UNITED STATES PATENT AND TRADEMARK OFFICE

Office Action Summary	Application No. 10/552,593	Applicant(s) MOMMA ET AL.	
	Examiner GERARD T. HIGGINS	Art Unit 1794

DETAILED ACTION

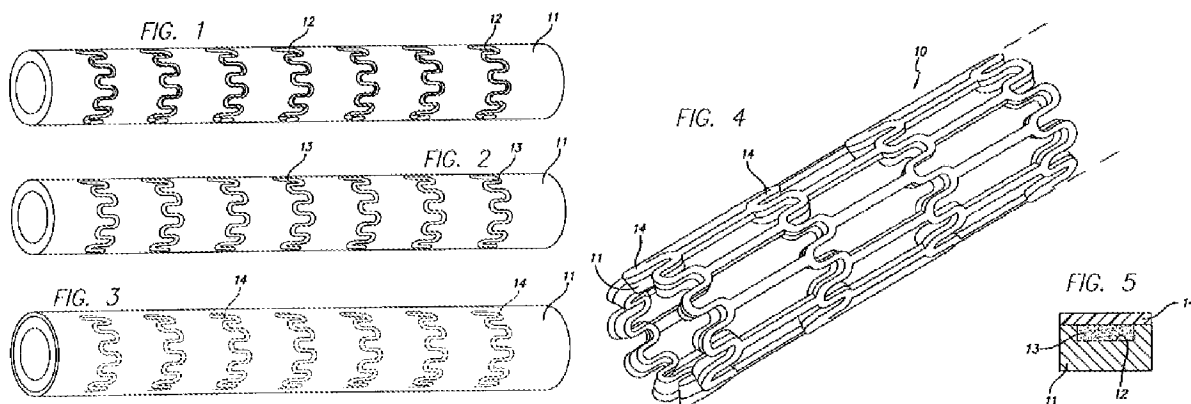
7. Claims 1-3, 6, 9, 11, 12, and 20 are rejected under 35 U.S.C. 102(b) as being anticipated by Dang (6,471,721).

With regard to claim 2, Dang discloses the device of Figures 1-5.

The stent **10**, which reads on applicants' carrier structure, comprises a radiolucent material, i.e. "difficult to visualize fluoroscopically" (col. 3, lines 22-31 and col. 5, lines 12-23). The stent is produced from a cut out metal tube stock **11** (see Figure 1). The device may have radiopaque material **13**, which reads on applicants' comparatively radiopaque material, incorporated therein (col. 5, lines 38-41). Please note from Figures 1-3 that the radiopaque material is incorporated in cylindrical cut grooves **12**

around the circumference of the tube stock (Figure 1-3). The cylindrically cut grooves are then covered over with the sputtered coating **14**. The tube stock **11**, with the cylindrically cut grooves **12**, filled with radiopaque material **13**, and then covered over with the sputtered coating **14** read on applicants' at least one marker element. The marker elements are attached to the rest of the carrier structure **10** (Figure 4). Please note that the marker elements are integral to the carrier structure; however, the longitudinal sections of the stent **10** spanning the distance between the cylindrical marker elements read on applicants' carrier structure (Figure 4). The radiopaque material **13** is completely enclosed by the tube stock **11** and the sputtered coating **14**, which together (**14** and **11**) read on applicants' cover layer. The material for the tube stock and the sputtered coating include metals and metal alloys (col. 5, lines 14-20 and col. 6, lines 9-11).

Although formed by a different process, i.e. forming grooves **12**, filling with radiopaque material **13** and covering over with the sputtered coating **14**, the Examiner deems the cover layer (**14** and **11**) has the same resultant structure as a hollow wire into which the radiopaque material fills the core thereof as claimed. Additionally, although the marker elements are integral to the carrier structure and not "welded in at least one of the apertures" as claimed, the Examiner deems the resultant structure to be the same, and therefore the device of Dang continues to anticipate the claimed invention.

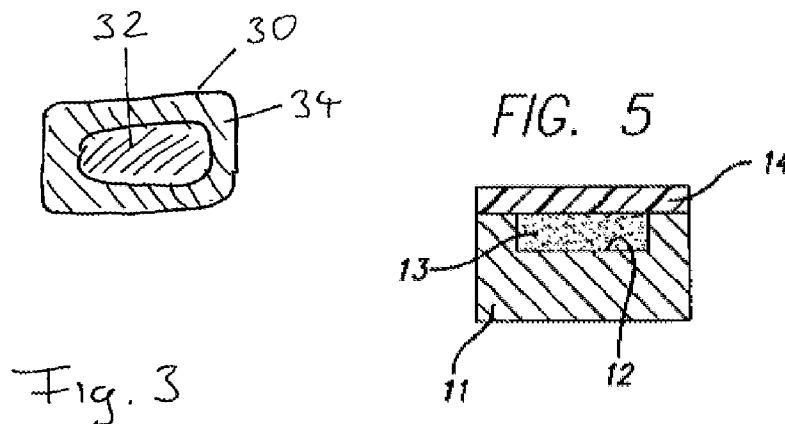
With regard to claim 5, Dang discloses all of the limitations of applicants' claim 2 in section 7 above, and it also discloses at col. 6, lines 56-57 that a biocompatibility layer may be added; however, it fails to disclose that the biocompatibility layer contains silicon carbide.

Kranz et al. disclose at col. 2, lines 51-54 that silicon carbide is used as an outer coating layer on the biocompatible stent and counteracts thrombosis formation; further, at col. 4, lines 27-30 that the silicon carbide is used as an outer covering to avoid stenosis.

the silicon carbide outer covering layer of Kranz et al. as the biocompatibility layer of Dang. The motivation for doing so has been stated above and includes *inter alia* counteracting thrombosis formation; further, the overcoating of silicon carbide on the device of Dang would produce a stent that had a multilayered covering layer, and as such would still include the nitinol cover (a metal or metal compound) as well as the additional layer of silicon carbide.
